**Kingmoor ERF**

**Fortum Carlisle Limited**

Schedule 5 Response

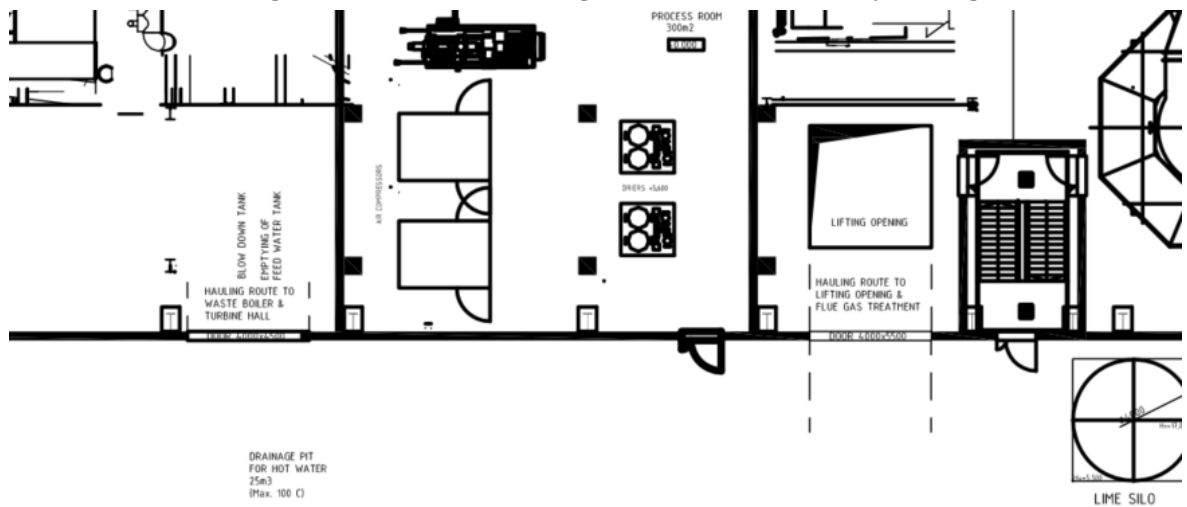
9. Please clarify where fuel oil will be stored section 2.1.2 of supporting documents state:

*'Fuel oil will be used on site ...fuel can be stored in dedicated storage tank'.*

A 'materials storage areas' drawing has been incorporated into Appendix A8 of the updated Fire Prevention Plan (refer to Appendix C). As can be seen from the drawing, the oil tank (for fuel oil) is located to the left of the ammonia tank at the bottom half of the site.
